18/1007/FUL | Planning application for a mixed-use development comprising Class A1 retail units; Class A1/A3/A5 food and drink units with drive through facilities and Class D2 health & fitness use on the site of the Police Headquarters, Devon And Cornwall Constabulary Police Training College, Alderson Drive, Exeter EX2 7HQ.

13th September 2018

Thank you for consulting the Exeter Cycling Campaign on the planning application for the development of a retail park on the site of the Police HQ at Middlemoor. The Exeter Cycling Campaign object to this proposed development for the reasons set out below:

Figure 1: Devon Collision Map, showing numerous collisions along Honiton Road with high numbers of collisions in the immediate vicinity of the proposed development.

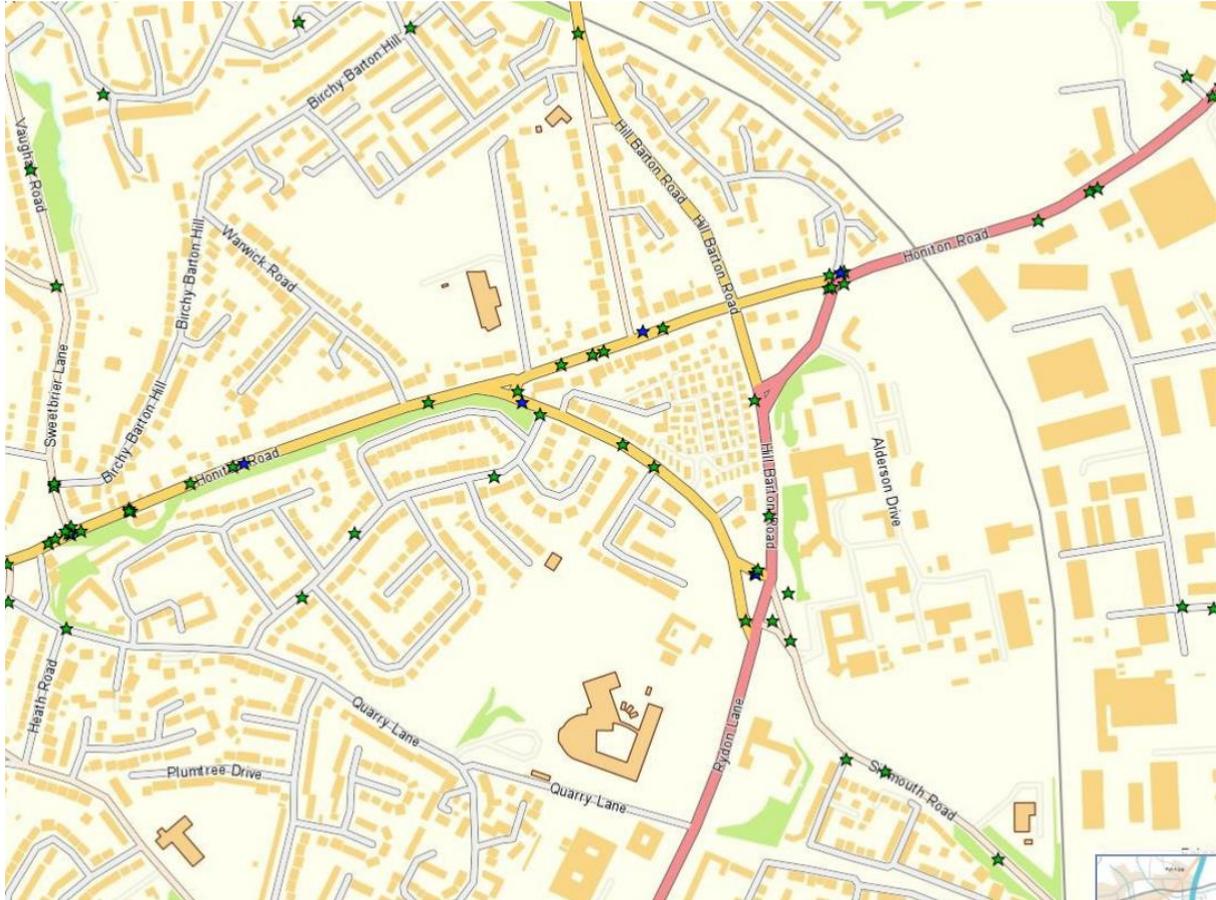
The Devon Collision Map, providing data between January 2013 and December 2017, shows multiple collisions in the vicinity of proposed development site (Figure 1), with seven collisions close to the entrance of the site, including one that was classified as serious. This demonstrates that in its current state the existing infrastructure is not safe.
